Campaign no.: 2020-0007

April 1, 2020 Subject: Can-Am® Spyder RT – Emergency Braking Situation: Possible Sudden Loss of Brake

2020-5

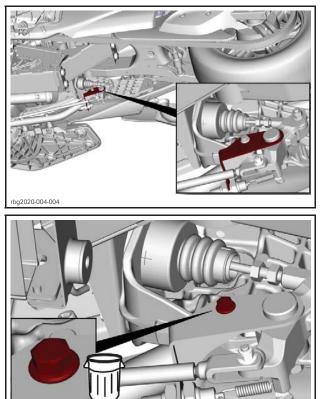
4. Remove the primary muffler retaining springs. **NOTE:** It is highly recommended to use the following tool.

rbg2020-004-005_a

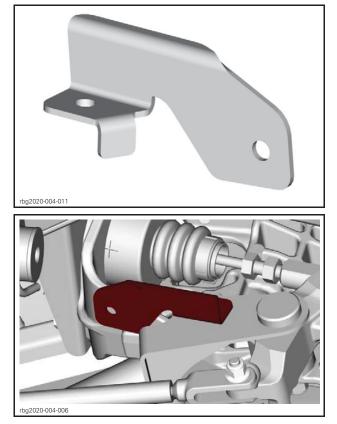
- 5. Remove the primary muffler from the vehicle.
- 6. Remove and discard the screw from the brake light switch bracket.

7. Position the bracket onto the brake light switch and the footrest support.
